Desalinated Water Delivery System:
application for modification of Project Approval
for the Botany Bay Sector
for
Water Delivery Alliance
Sydney's Desalination Project

Executive Summary

The Water Delivery Alliance (WDA) has been established to design, construct and commission the pump station and desalinated water delivery system linking the desalination plant on the Kurnell Peninsula with the existing distribution network at Shaft 11C, Erskineville.

Figure 2.1: Project as described in the PPR

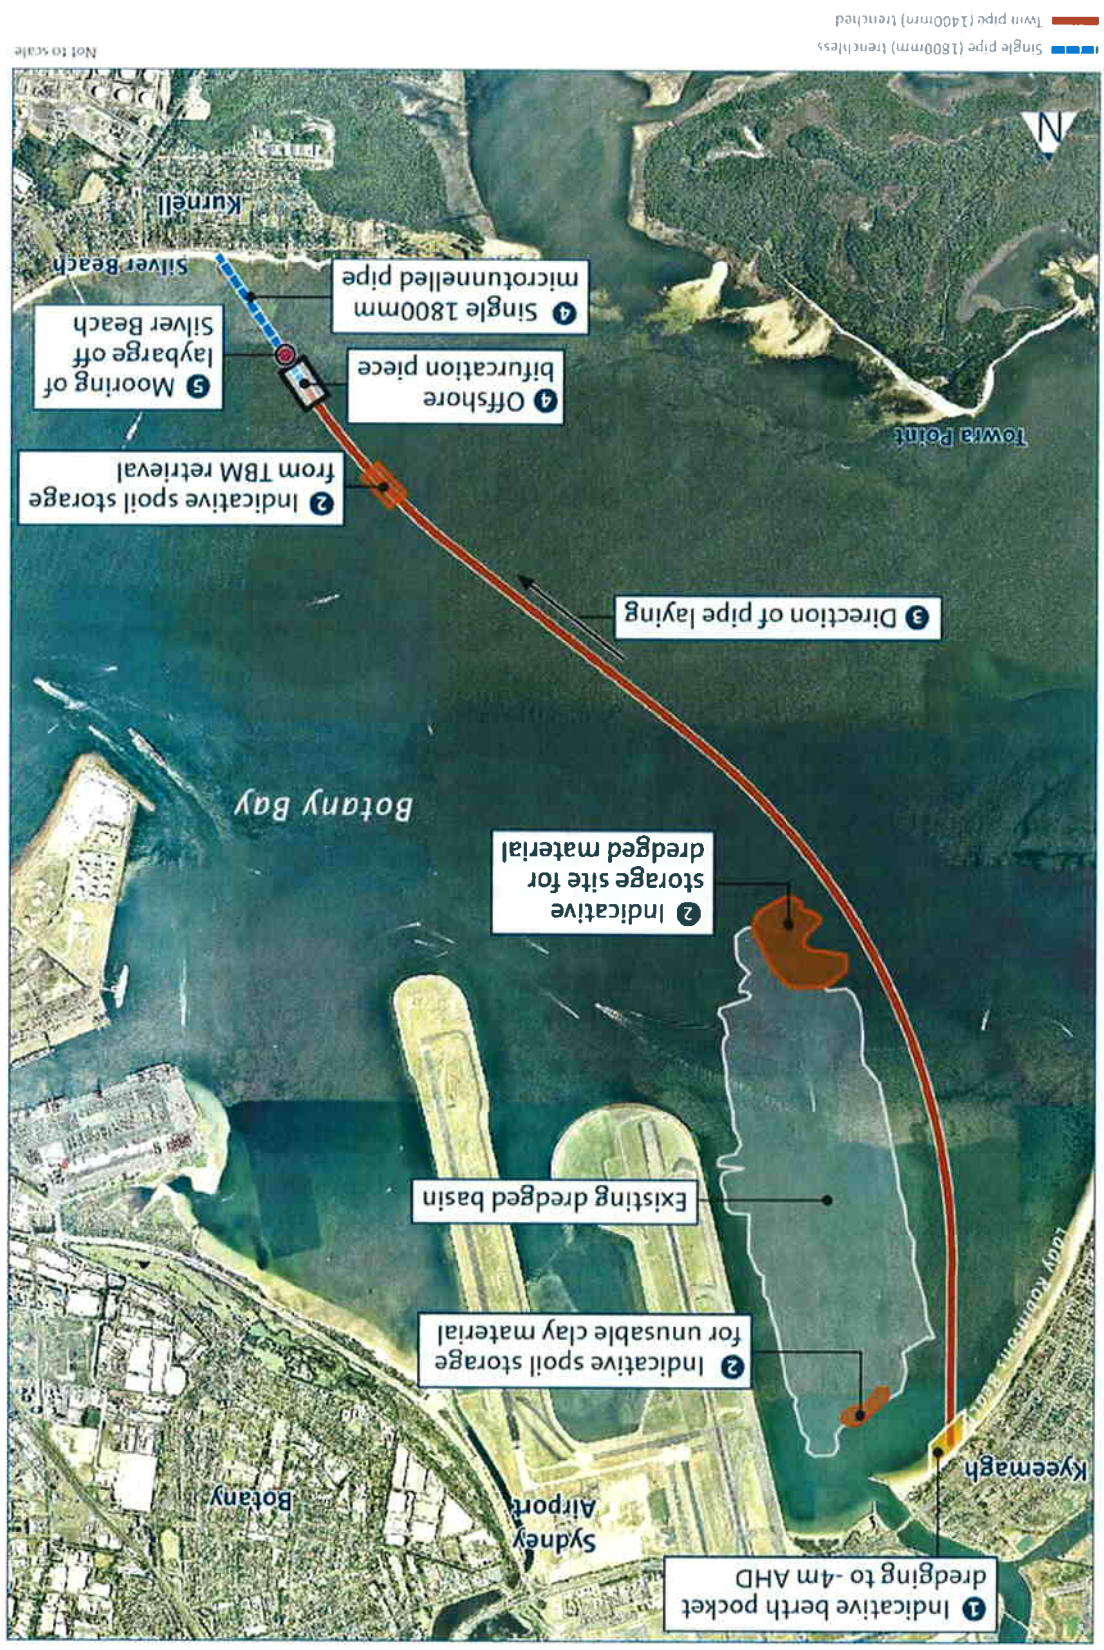
Figure 2.1 shows the project as described in the PPR.

Figure 2.3: Proposed berth pocket dredging

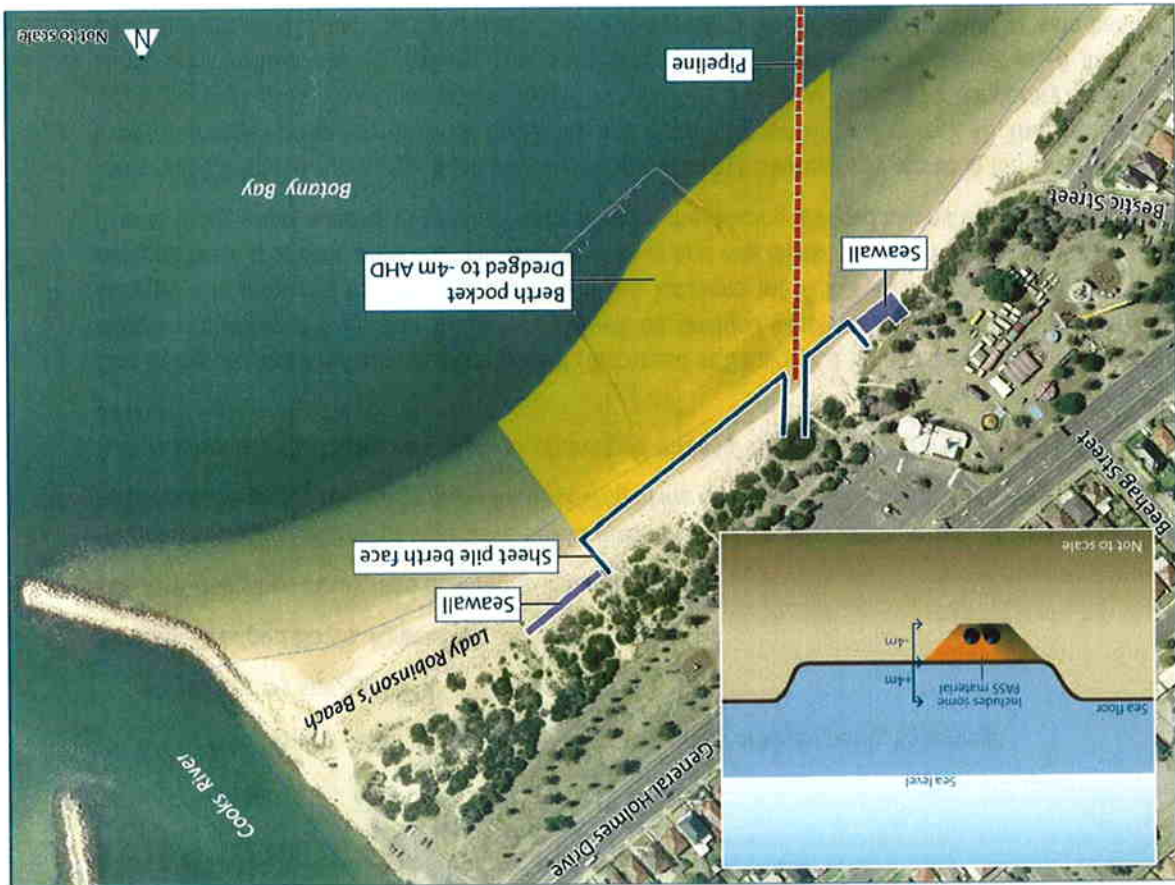
- dredging of a berth pocket at Kyeemagh instead of construction of a temporary work platform.

Further consideration of the construction method through the Kyeemagh beach zone has indicated that construction of the temporary work platform is no longer required. Instead, it is proposed to dredge a berth pocket to a level approximately 4 m Australian Height Datum (AHD) (Figure 2.3), which would allow the pipe laying barge (or 'lay barge') to be fitted-out on site.

Approximately 52,000 m³ of sandy material would be dredged to create the Kyeemagh berth pocket. The dredged material would be temporarily placed within the southern portion of the existing dredged basin, adjacent to the main north-south airport runway, as per the PPR (Section 2.3.2 and Figure 2.4).

The dredging of the proposed berth pocket also allows the pipe trench to be dredged directly to the sheet piled berth face (-8 m AHD), no longer requiring the twin 1,400mm pipes to be installed between the sheet piles of the temporary work platform. This is illustrated by the cross section shown in Figure 2.3, and is a much simpler process in terms of construction and amount of material requiring storage and handling. Additionally, the pipe trench will be dredged through a band of firm to stiff clays, requiring a reduced trench batter (angle), resulting in less material to be dredged, stored and managed (Section 2.3.2). This reduction in material to be handled is in the order of 8,000 to 10,000 m³.

Figure 2.6: Indicative lay barge operation

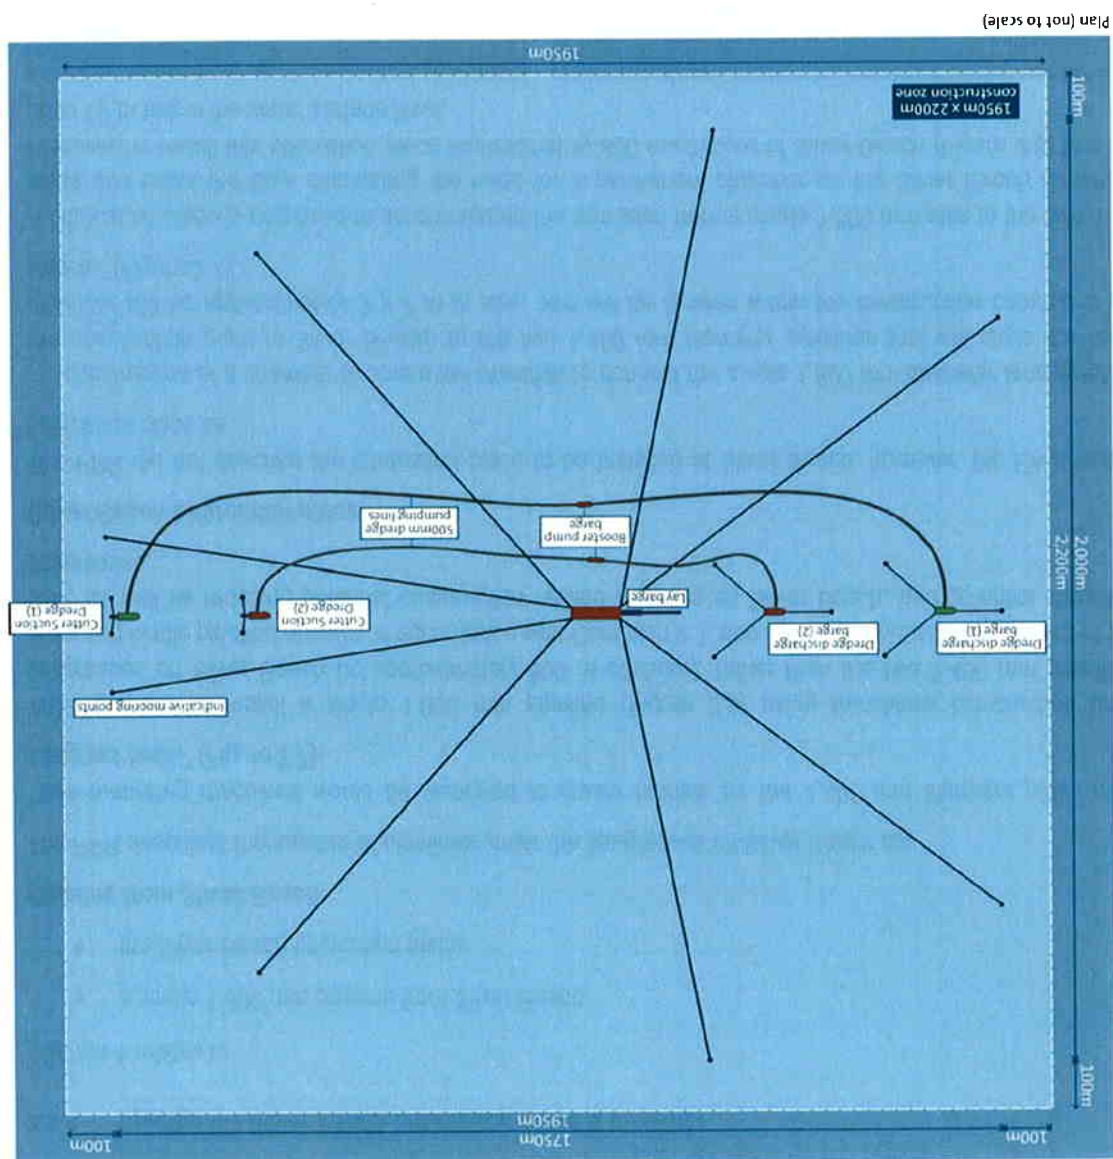
The proposed change increases the installation operation spread from the approved project of 1,300 m to approximately 1,750 m. The length of the fully formed trench, being the distance between the cutter suction dredge (CSD) 2 and discharge barge 2 (Figure 2.6), has now increased from 900 m to in the order of 1,100 m.

The largest change to the installation operation spread is associated with the mooring arrangement. The PPR identified an indicative mooring arrangement that was significantly smaller compared to the overall installation operations. Since preparation of the PPR, a considerable amount of marine engineering calculations have been undertaken to identify an appropriate mooring arrangement, which is approximately 1,750 m by 2,000 m (Figure 2.6). These calculations considered the:

As such, the construction zone around the vessels also increases, with likely dimensions of 1,950 m by 2,200 m (Figure 2.6). This includes a buffer of 100 m in front, behind and on the sides of the mooring arrangement. The proposed construction zone would move progressively across the Bay at a rate of approximately 108 m/day, for a period of approximately 5 months (excluding the shore crossings). This is a reduction in time taken to cross the Bay from the PPR, which identified 96 m/day over approximately 6 months.

Figure 2.8: Indicative bifurcation piece off Silver Beach, Kurnell

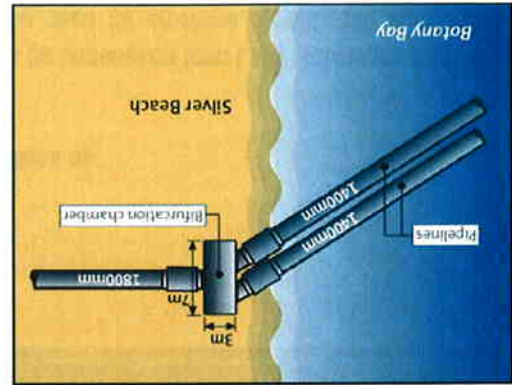
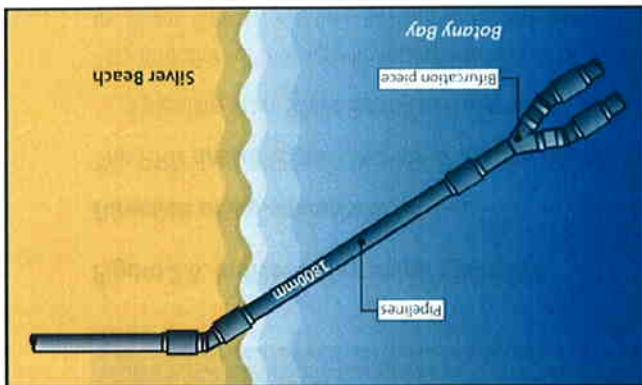
"Two tunnelling machines would be launched to create tunnels for the 1,400 mm diameter pipes under the seagrass beds." (Figure 2.7)

WDA propose to install a single 1,800 mm pipeline (Figure 2.8) using trenchless construction under the seagrasses off Silver Beach (to approximately 800 m offshore), rather than the two 1,400 mm pipelines. The proposed single pipeline remains in accordance with Condition 2.1, and will save a substantial amount of time and cost, as well as reducing potential construction related activities on Silver Beach, and potential impacts to the seagrasses.

A bifurcation piece is proposed to accommodate the transition from a single 1,800 mm pipe to the twin 1,400 mm pipes that cross the Bay, eliminating the need for a permanent chamber on the Silver Beach foreshore. It is proposed to install this bifurcation piece approximately 800 m offshore of Silver Beach (Figure 2.8) to a depth of up to 12 m below the water surface level.

Figure 2.9: Illustration of the mooring lines (floating ropes) through the Silver Beach zone

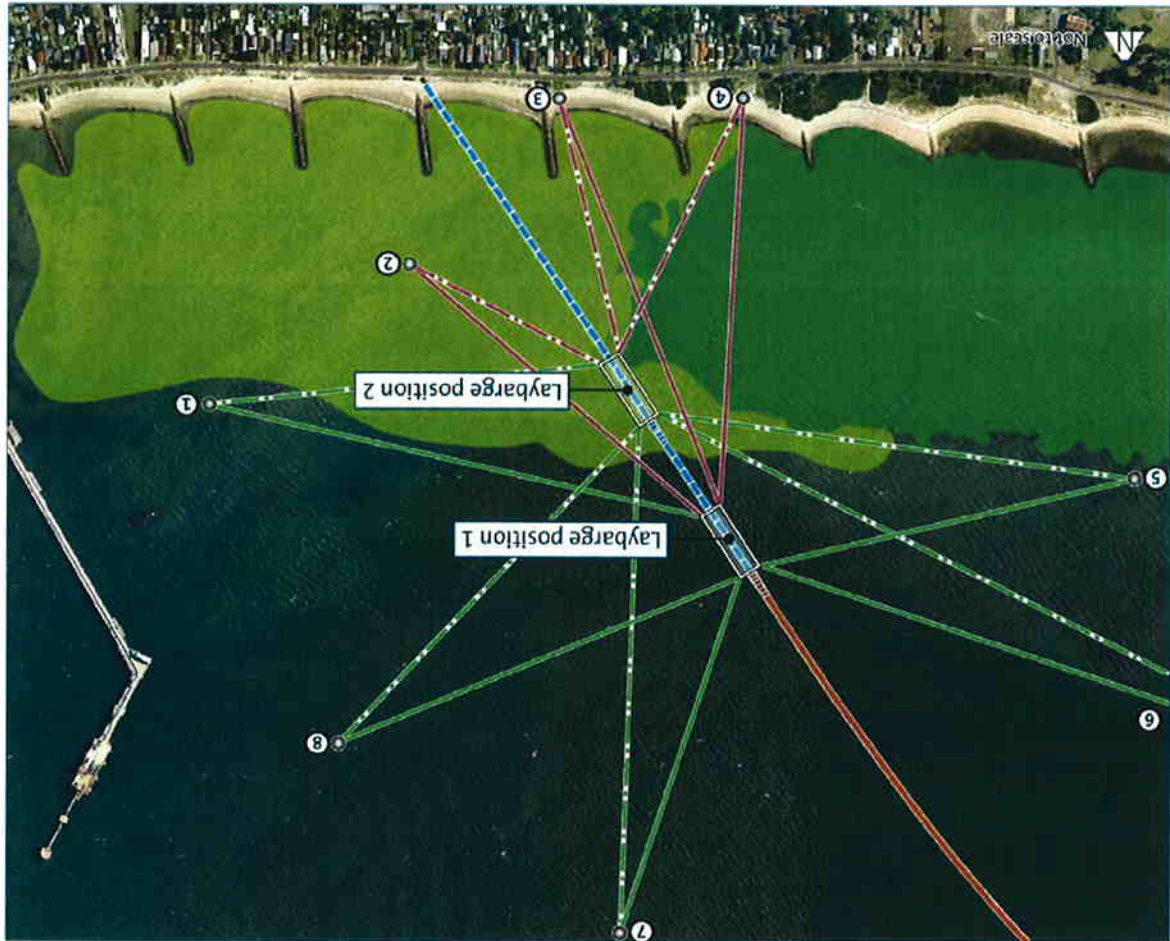
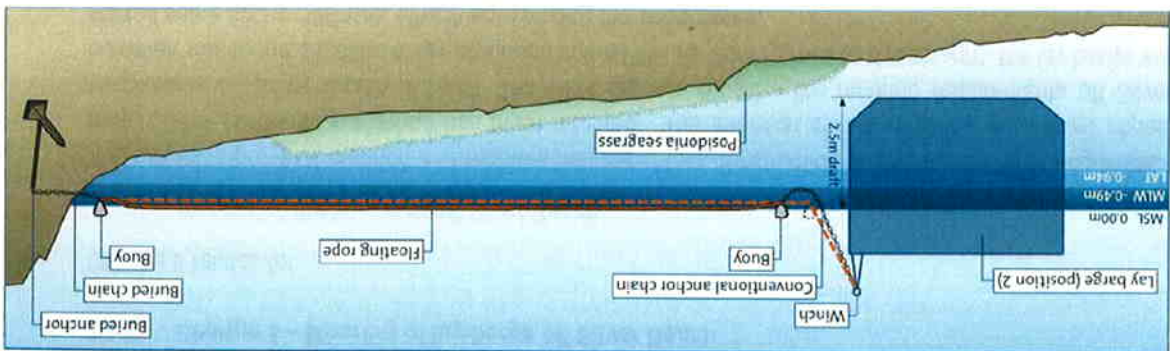
As discussed in Section 2.3.3, it is proposed to reverse the direction of the lay and lay from Kyeeemagh to Kurnell. This change in the direction has meant that the proposed lay barge operations off Silver Beach require mooring adjacent to, and over the seagrasses to lay the final sections of the twin 1,400 mm pipes and the bifurcation piece.

Following substantial investigations of possible options, and in consultation with the Department of Primary Industries (DPI), the proposed lay barge mooring system has been developed to minimise potential impacts to the seagrasses off Silver Beach. The proposed methodology involves a mooring arrangement that avoids areas of dense *Posidonia* beds off Silver Beach by using floating ropes and buried onshore anchors (as shown in Figure 2.9). This approach ensures that Mooring Lines 3 and 4 associated with the lay barge remain generally clear of the *Posidonia* seagrass. However, there is the potential for impacts, as during some low tides the *Posidonia* beds at the shoreline will become exposed, reducing the effectiveness of the floating ropes.

In addition, as the lay barge reaches Position 1, Mooring Point 2 is unable to be placed onshore due to the presence of the existing Silver Beach groynes. Consequently, it is necessary to anchor Mooring Line 2 offshore, within areas of patchy seagrass. Where practical, this anchor will be placed in a gap in the patchy seagrass to further minimise potential impacts to the seagrasses.

Figure 2.10: Indicative location of the water quality probes

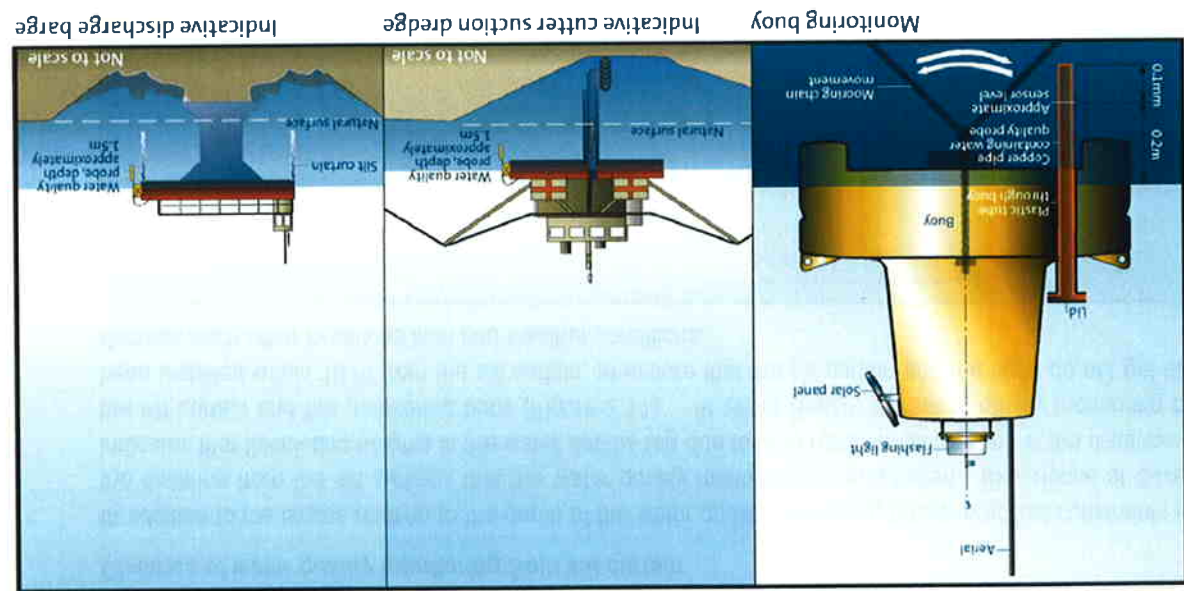
As discussed in Table 2.2, the location of the sensor for the discharge barge and CSD is somewhat flexible and the depth adjustable based on the water depth as the barge/dredge crosses the Bay. In relation to the shore-based construction sites, or where water depths are shallower and monitoring buoys are used, the depth of the water quality monitoring probe is less flexible.

The water quality monitoring probe set within the water quality monitoring buoy has been designed to minimise potential for damage and tangling with the mooring chain or silt curtain. The probe is located within a copper pipe, encased by a plastic tube that runs through the buoy. The probe sits approximately 0.2 m below the surface of the water (Figure 2.10), rather than at mid-depth in the water column. This set-up is required as it:

As such it is proposed to amend the condition relating to the depth of water monitoring as follows:

Figure 2.11: Relation of water quality buoy mooring lines to the silt curtains

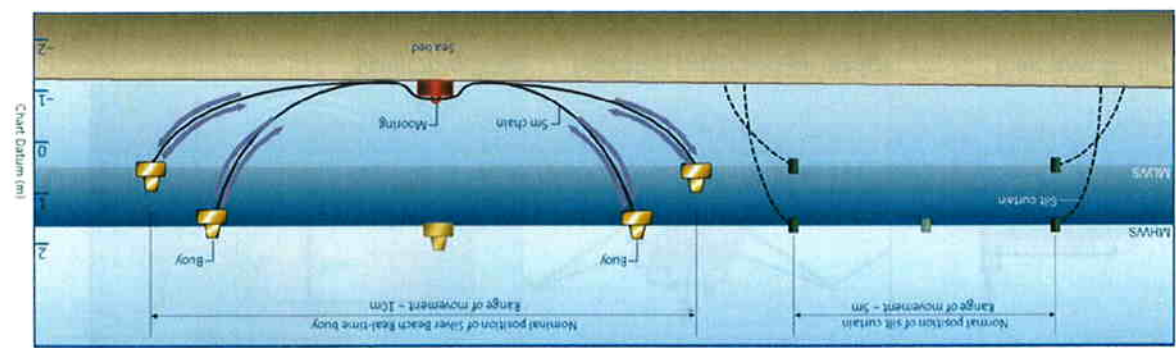
In addition to the issues relating to the depth of the water quality monitoring probe, practical constraints influence the distance from the silt curtains that the water quality monitoring is undertaken. Experience at Silver Beach indicates that fluctuating heights in the water depths (eg due to tide) result in fluctuations in the distance between the silt curtain and the monitoring buoy (Figure 2.11). At Silver Beach, the water quality monitoring buoy has been installed within 10 m from the silt curtain, to ensure that the silt curtain and the buoy do not get tangled or damage each other in various tidal and weather conditions.

Figure 2.11 shows the movement of both the silt curtain and the monitoring buoy in response to variations in the tide conditions. The figure suggests that a more practical distance to undertake water quality monitoring would consider the variable conditions of the Bay, and be say 'within 10 m of the silt curtain'. Table 2.3 identifies the likely distance associated with the water quality monitoring equipment from the silt curtains (or CSD, as relevant).
